**Re: Agnico Eagle Mines – Meadowbank Division Responses to Mammoth Dike Design Report Comments**

- CIRNAC – November 20 4, 2018, Crown-Indigenous Relations and Northern Affairs Canada (CIRNAC) response to Agnico Eagle Mines Limited's (AEM's) Mammoth Dike Design – Whale Tail Pit Project under AEM's Type "A" Water Licence No. 2AMWTP1826.

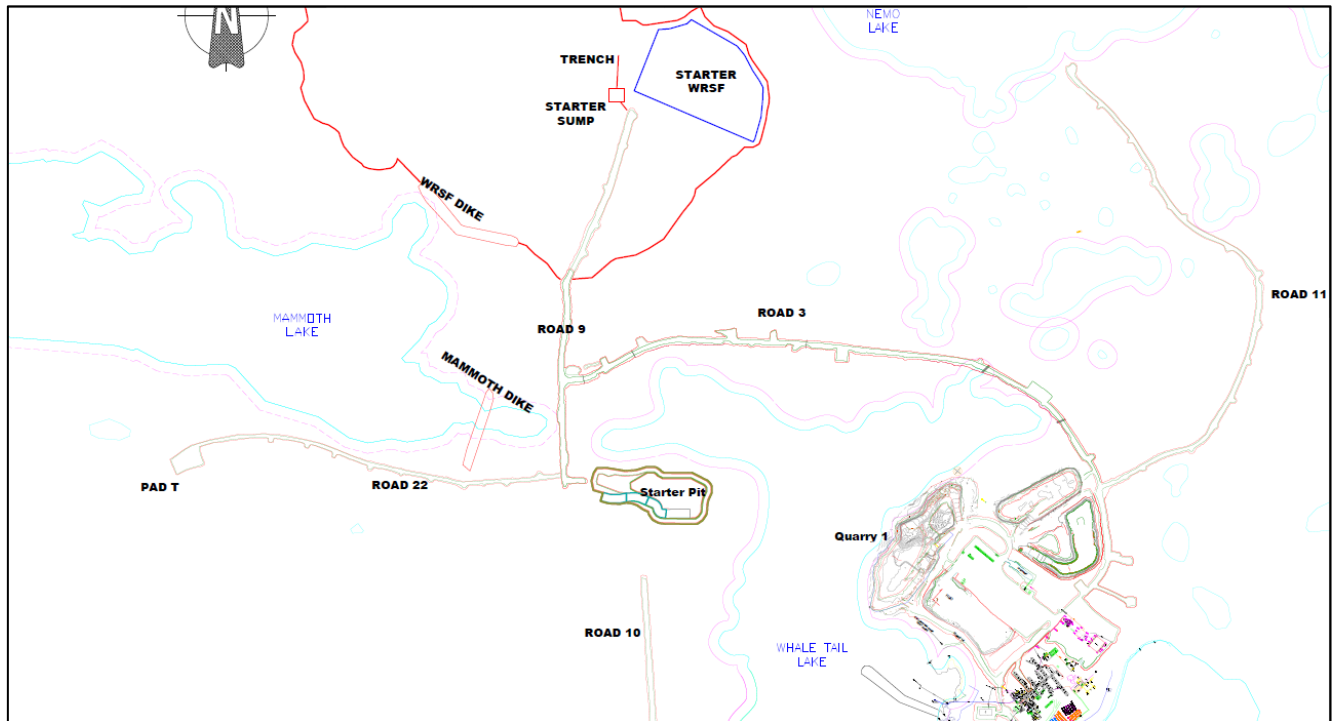
**Comment 3:** No dike access details have been provided. CIRNAC recommends AEM to provide adequate details for any required access roads to access the dike during high flow periods for routine inspections and regular maintenance.

*The access road to Mammoth Dike was not included in the dike design. A site road adjacent to the dike (road #22), subjected to a 60 day notice sent on July 13<sup>th</sup> 2018 and approved for construction on September 4<sup>th</sup> 2018, is already existing and will be used as the access road. Access to the dike crest will be restricted to light vehicle for inspection and maintenance purpose.*
